Wilmette Park District: __Centennial Recreation Complex_____

Addendum #: _1__

Subject: Relocation Update___

Project name: Fire Hydrant Relocation_____

UTILITY PLAN - SOUTH

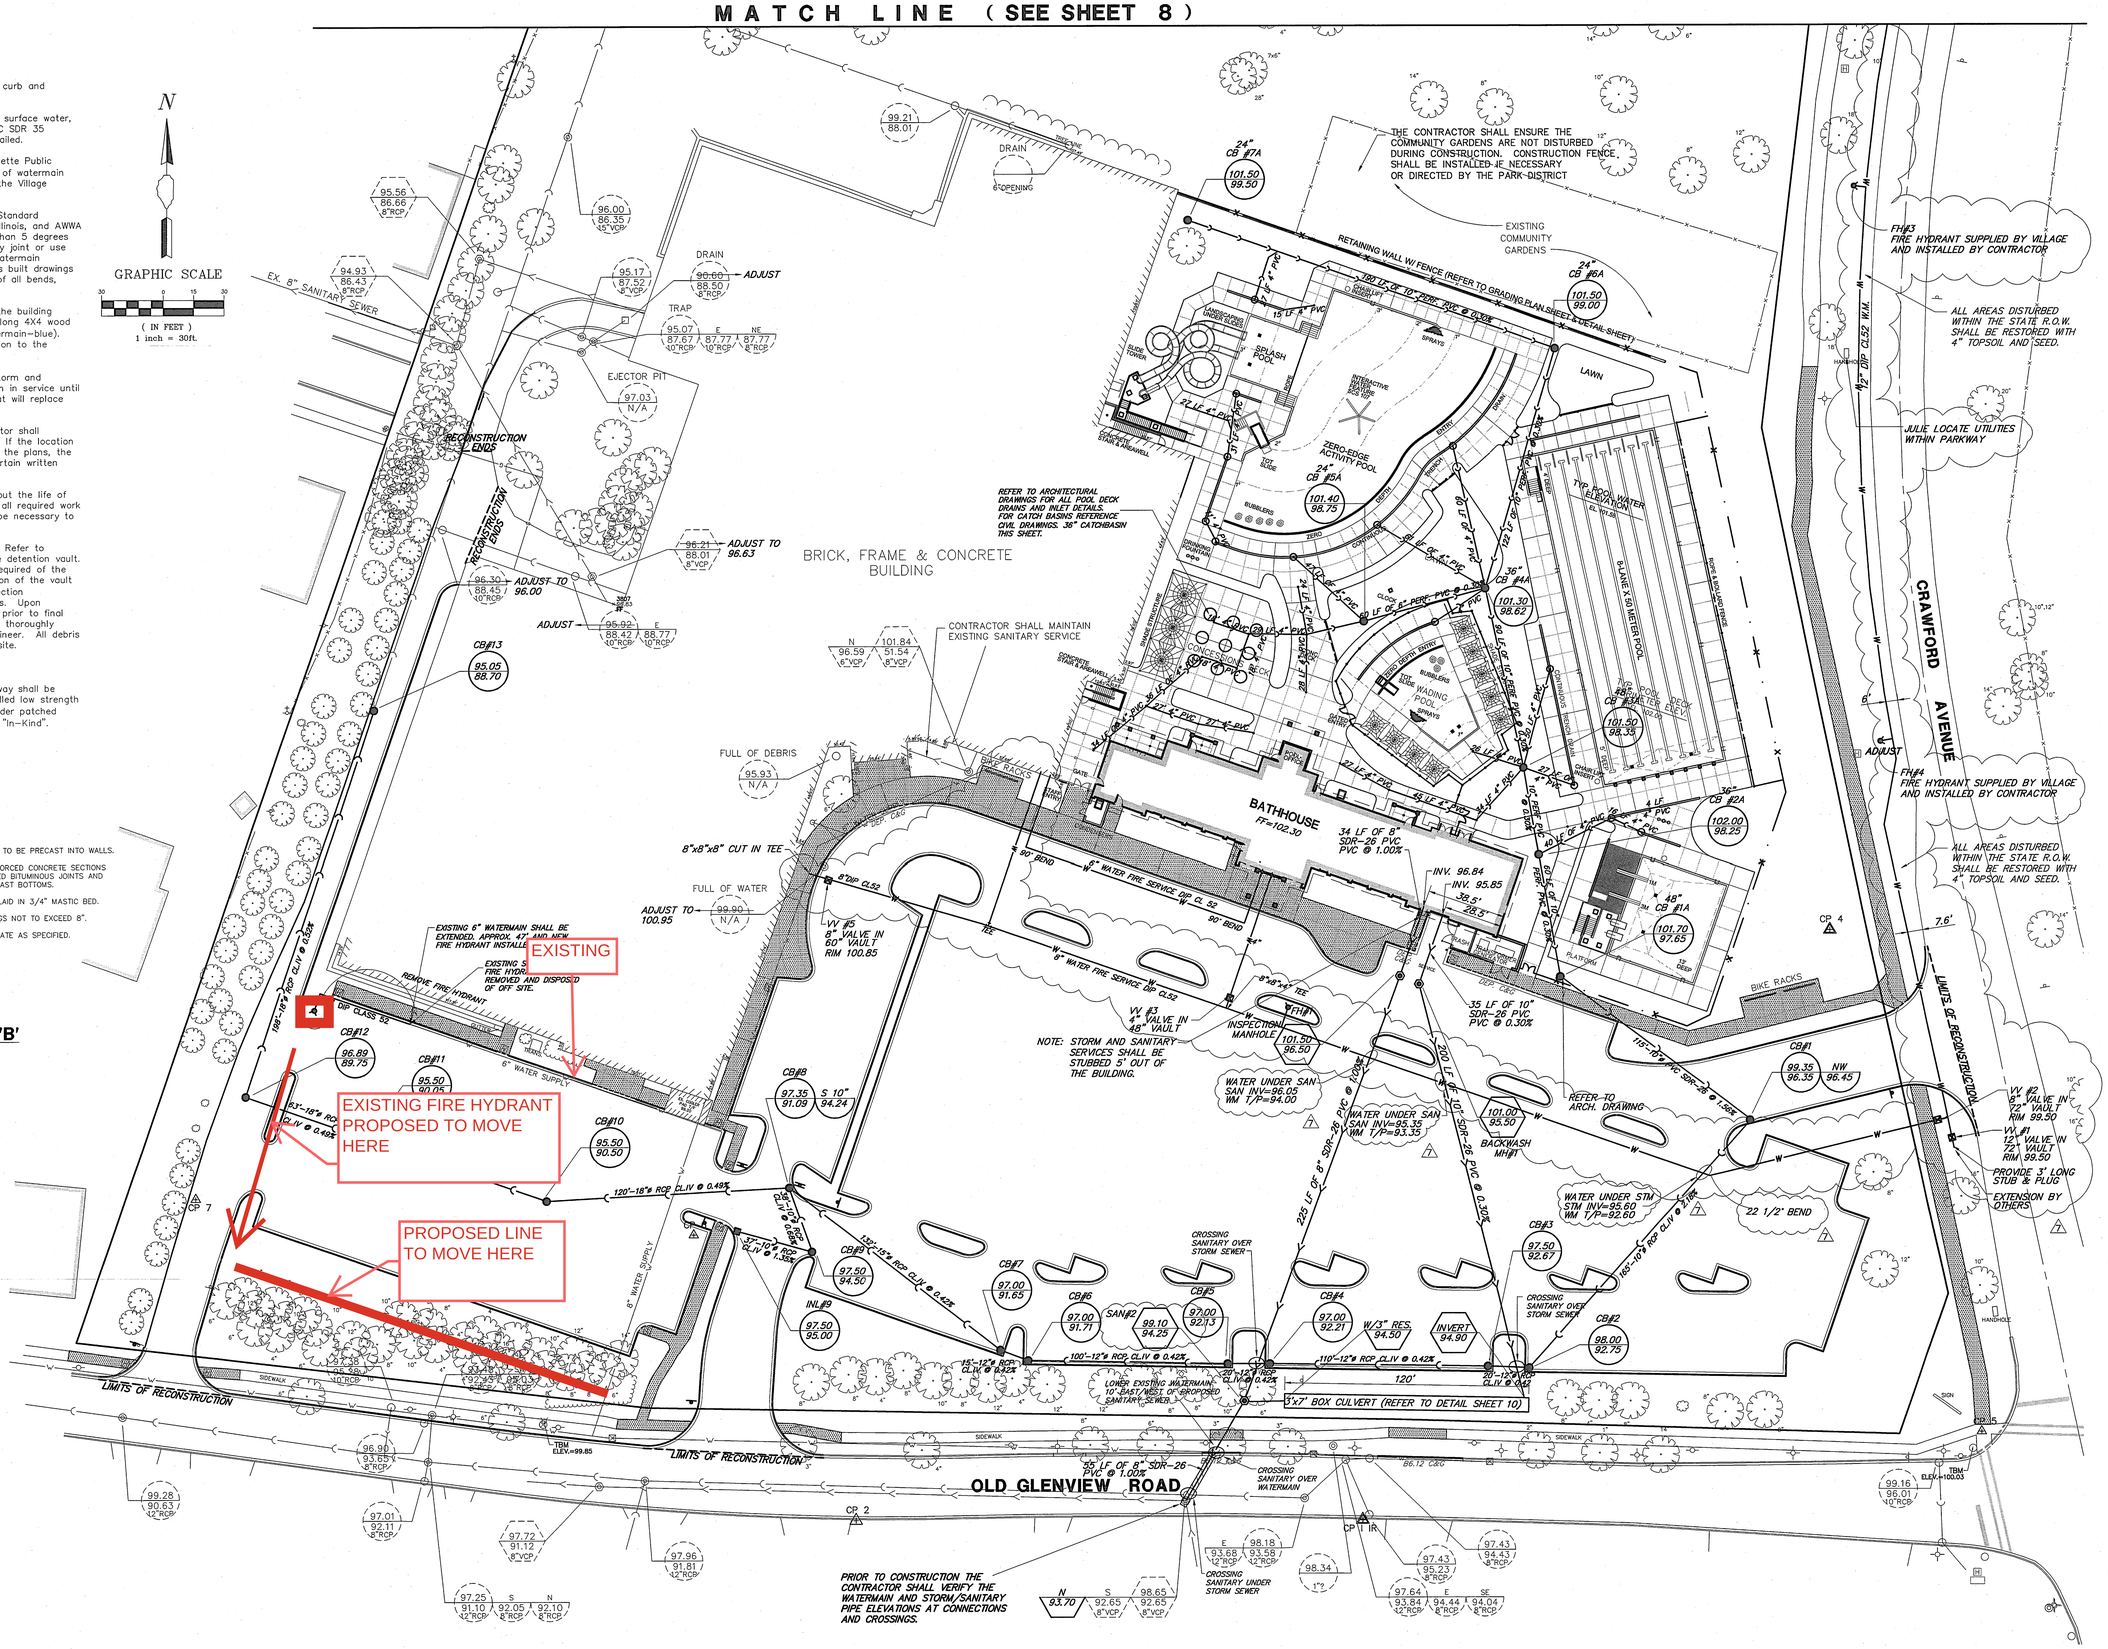
1. **Revised Water Main Alignment**
   The base bid shall include installation of the new water main parallel to Old Glenview Road, within the existing grass area, extending to the proposed fire hydrant location as indicated on the attached drawing. The revised alignment is intended to avoid excavation and restoration of the existing parking lot. All bidders shall base their proposals on this revised alignment.

5. **Fire Hydrant Specifications**
   The new fire hydrant shall be a Waterous hydrant equipped with a Storz connection.
6. **Revised Drawing**
   The attached drawing identifies the required water main alignment and proposed fire hydrant location. This drawing shall be used for preparation of the base bid.
   All other terms and conditions of the original bid documents shall remain unchanged.
